CITY OF KIRKLAND

**ADVISORY REPORT
FINDINGS, CONCLUSIONS, AND RECOMMENDATIONS**

To: Eric R. Shields, AICP, Planning Director
From: _____ Tony Leavitt, Associate Planner
_____ Eric R. Shields, AICP, Planning Director
Date: March 25, 2009
File: JACKLING TOWNHOMES PROJECT (ZON08-00021)
Hearing Date and Place: April 2, 2009
City Hall Council Chamber
123 Fifth Avenue, Kirkland

LANDSCAPE PLAN

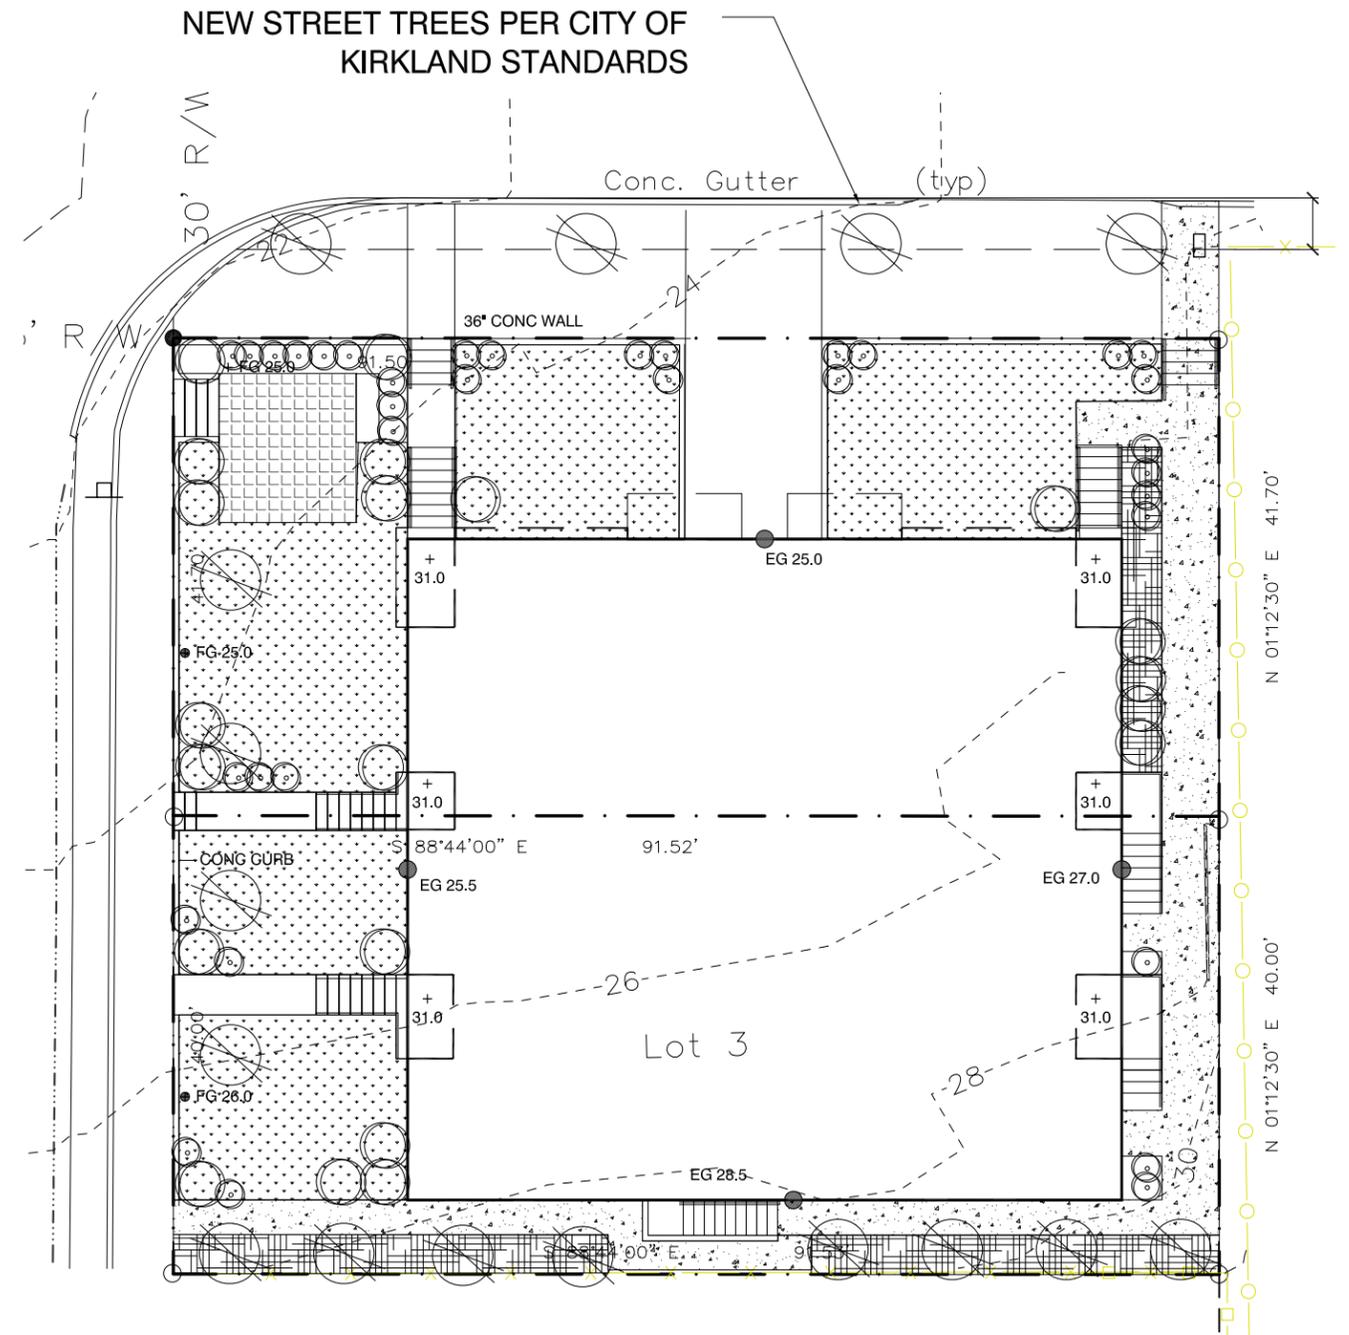
- (1) KZC Section 60.72.020 requires an "Attached Dwelling Unit" use in a PLA 6D zone to comply with Landscape Category D.
- (2) KZC Section 95.40.4 requires a landscape buffer for a use adjoining low density residential uses to comply with KZC Section 95.40.6.b.
- (3) KZC Section 95.40.6.b (Buffering Standard 2) requires a 5 foot wide landscape buffer that is planted with a mixture of trees, shrubs, and ground cover.
- (4) KZC Section 95.40.6.d requires that the applicant provide the required buffer along the entire common border between the subject property and the adjoining property.
- (5) The subject property adjoins a low density residential use to the east.
- (6) The proposed development does not identify a land use buffer along the east property line.

b. Conclusions:

- (4) The applicant's arborist recommends that the hedge row of photinia plants on an adjoining property be protected during construction.
- (5) The City's Urban Forester reviewed the Tree Plan II and concluded that all trees on the subject property are Type 3 trees that need to be removed to accommodate the development. Additionally, since the hedge row of photinia plants on the neighboring property are not significant trees, tree fencing is not required. Finally, she notes that the trees specified along the south property line attain a canopy spread of 30'. The landscape plan shows them spaced at 10' on center. The applicant may want to consider using a narrower-growing cultivar.

- (1) As part of the building permit application, the applicant should submit plans for a landscape buffer that complies with KZC Section 95.40.6.
- (2) Prior to final inspection of the building permit, the applicant should provide a final as-built landscape plan and an agreement to maintain and replace all landscaping that is required by the City (see Attachment 9).

- b. Conclusions:
 - (1) The applicant has complied with the requirements of KZC Section 95.35.2.b.2.
 - (2) As part of the building permit application, the applicant should submit a final tree retention plan that incorporates the recommendations of the City's Urban Forester and the applicant's Arborist.
